Addendum No. 03

Renovation Int/Ext & Install Generator – Multi Assets-General Headquarters Complex
MO State Highway Patrol
1510 E. Elm, Jefferson City, MO
PROJECT NO. R2502-01

Bidders are hereby informed that the construction plans and/or specifications are modified as follows:

SECOND FLOOR PLAN

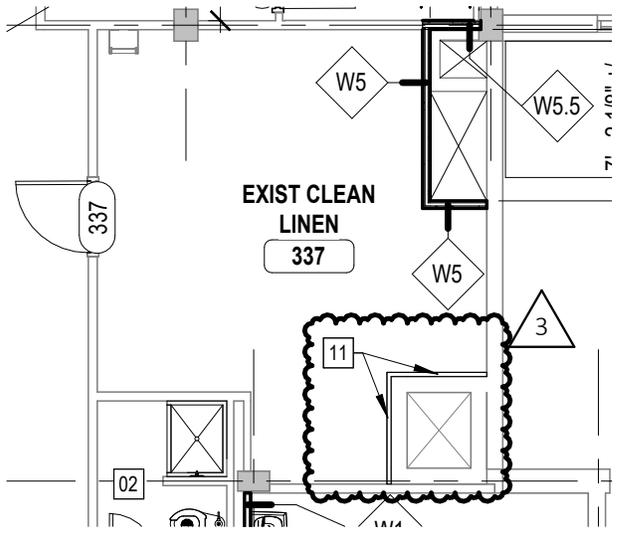
6. A-106 - DORM SECOND FLOOR PLAN (SEE ATTACHED ADD 3 DETAILS)

ADD: Detail 1 – SECOND FLOOR PLAN, at EXIST CLEAN LINEN 237, added keyed note 18 at the mechanical chase.

ADD: SECOND FLOOR KEYED NOTES: "18. (2) LAYERS OF TYPE X GYWB OVER 7/8" HAT CHANNEL. SEE DETAIL 5/A-406

18 (2) LAYERS OF TYPE X GWB OVER 7/8" HAT CHANNEL. SEE DETAIL 5/A-406.

THIRD FLOOR PLAN

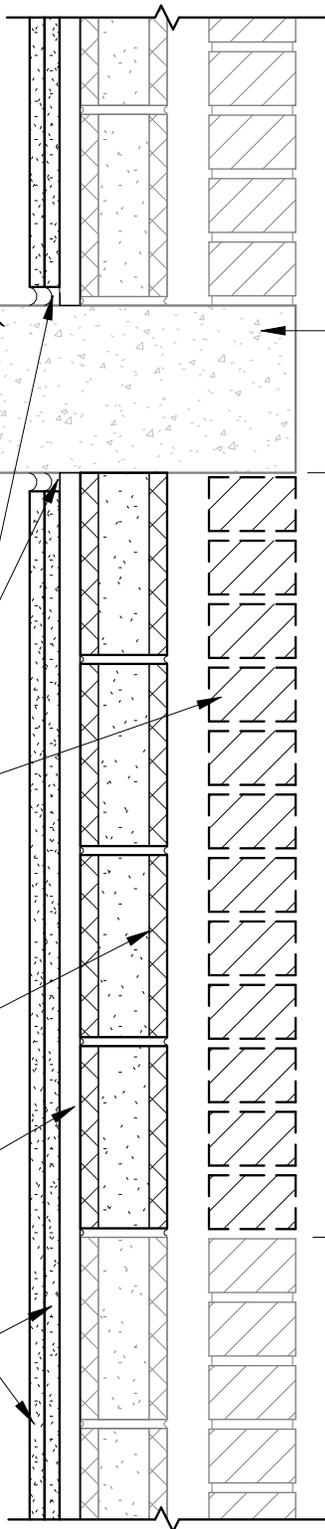
7. A-107 – DORM THIRD FLOOR PLAN (SEE ATTACHED ADD 3 DETAILS)

ADD: Detail 1 – THIRD FLOOR PLAN, at EXIST CLEAN LINEN 337, added keyed note 11 at the mechanical chase.

ADD: THIRD FLOOR KEYED NOTES: "11. (2) LAYERS OF TYPE X GYWB OVER 7/8" HAT CHANNEL. SEE DETAIL 5/A-406

11 (2) LAYERS OF TYPE X GWB OVER 7/8" HAT CHANNEL. SEE DETAIL 5/A-406.

SECTION THRU MECH. CHASE

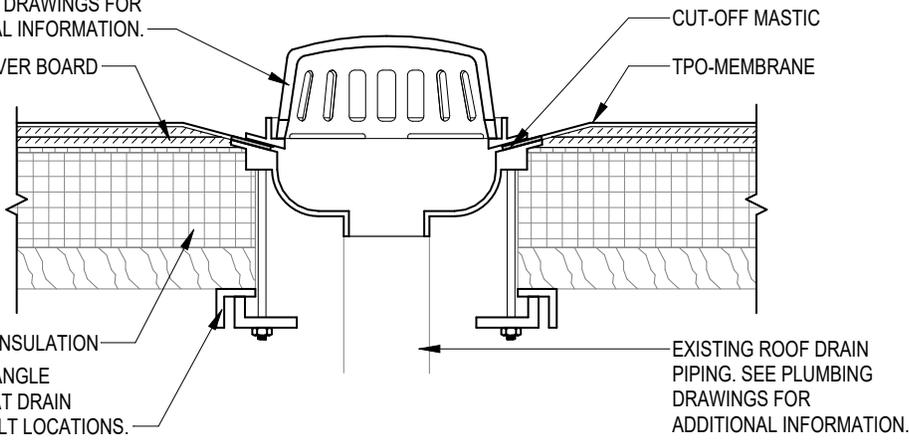
12. A-406 – DORM PARTITION TYPES & MISC. DETAILS (SEE ATTACHED ADD 3 DETAILS)

ADD: Detail 5 – SECTION THRU MECH. CHASE

REMOVE MINIMAL NUMBER
OF BLOCKS TO ACCESS
CHASE. REINSTALL
REMOVED CONC. BLOCKS
AT COMPLETION OF
MECHANICAL WORK

7/8", 20 GAUGE, METAL
FURRING ATTACH TO
EXISTING 4" BLOCK

(2) TYPE 'X' GYPSUM BOARD
STAGERED, FLOOR TO
CONC. DECK ABOVE. PAINT
PER FINISH SCHEDULE.

REMOVE 4 BLOCKS HIGH (FROM DECK DOWN)
X2 BLOCKS WIDE

2 ROOF DRAIN

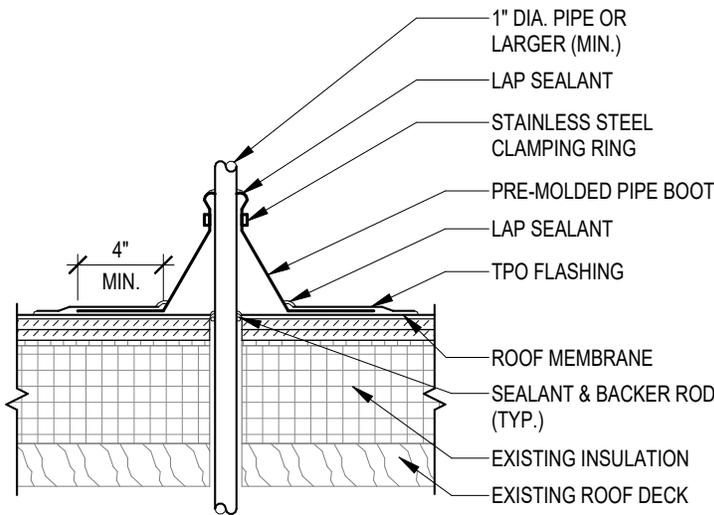
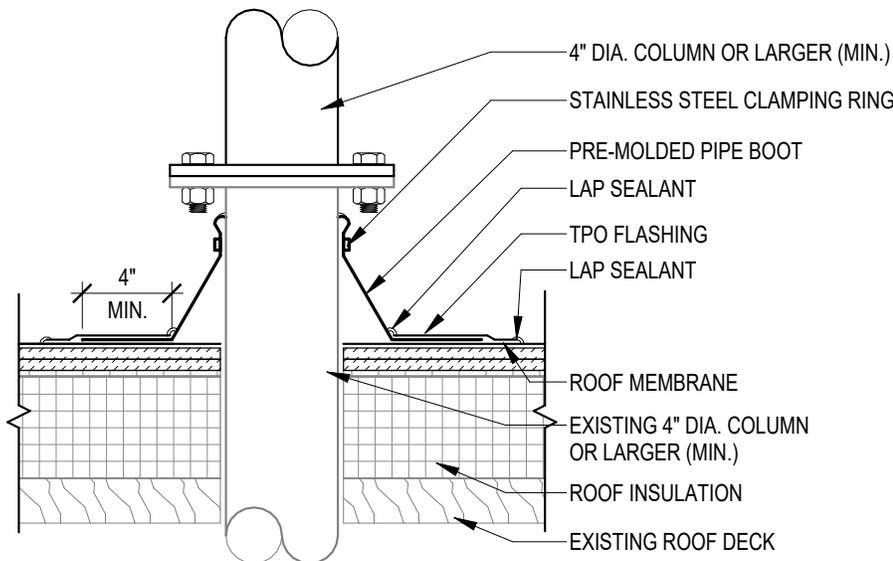
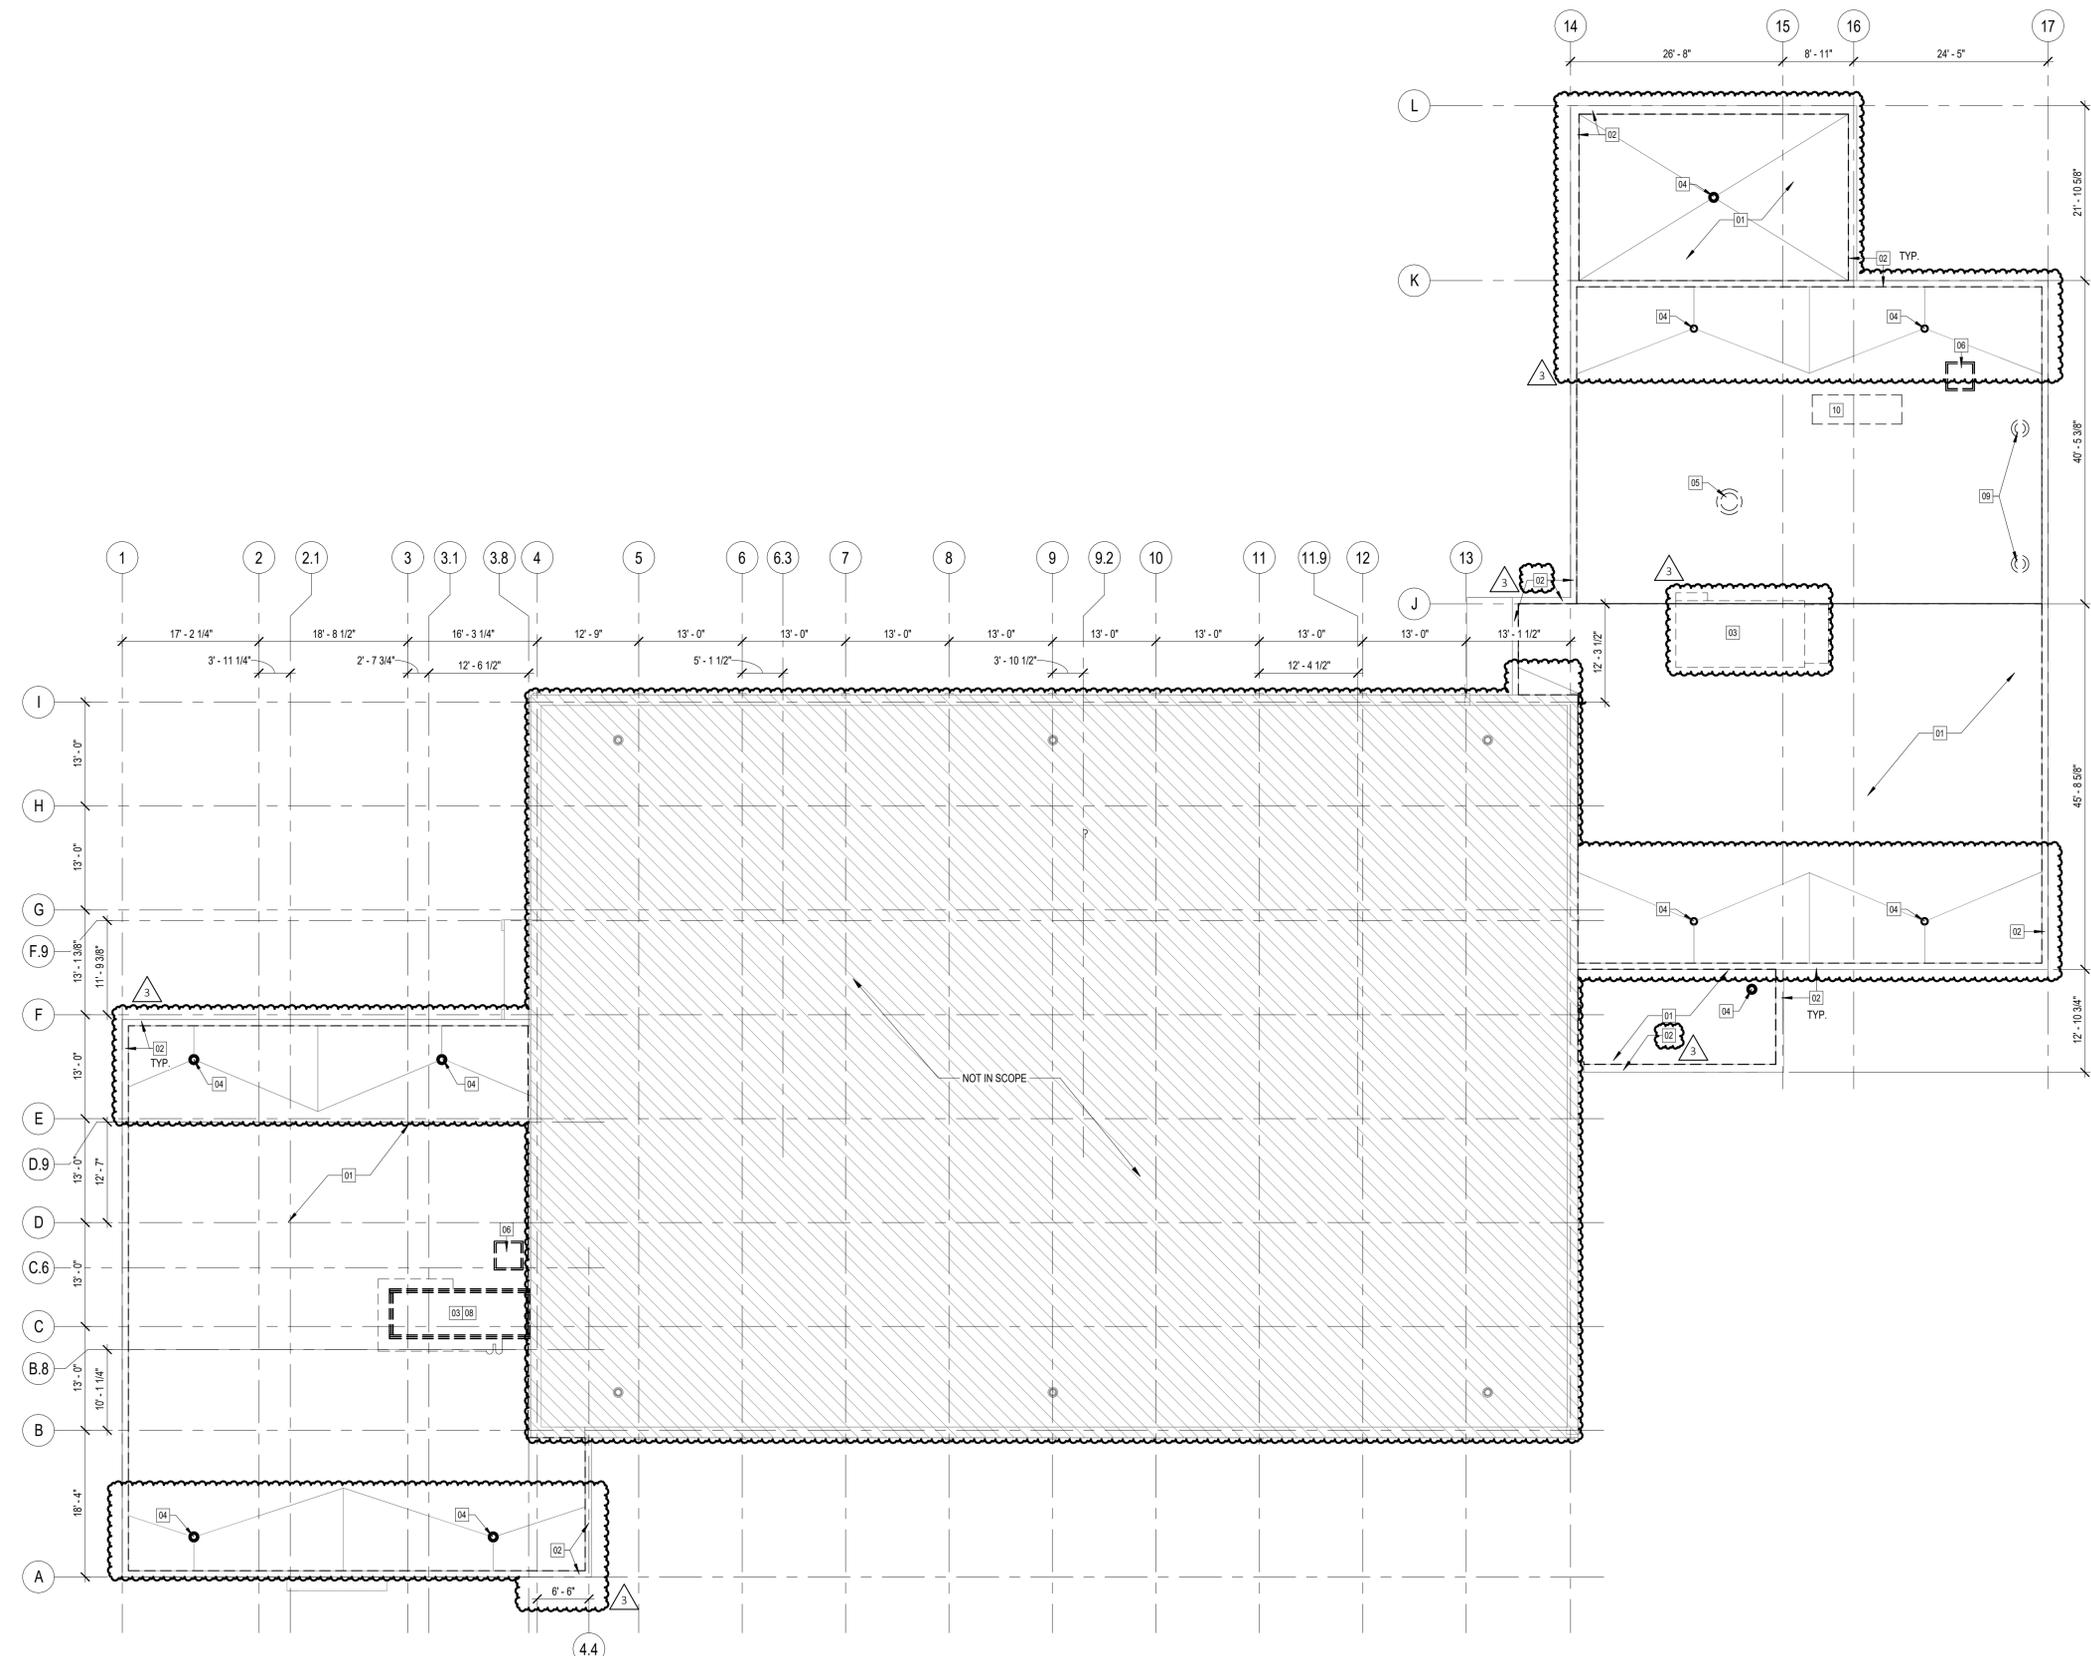
13. A-501 – DETAILS 2,3,4 (SEE ATTACHED ADD 3 DETAILS)

DELETE: Reroof down to substrate board

ADD: Revised to recover roof only
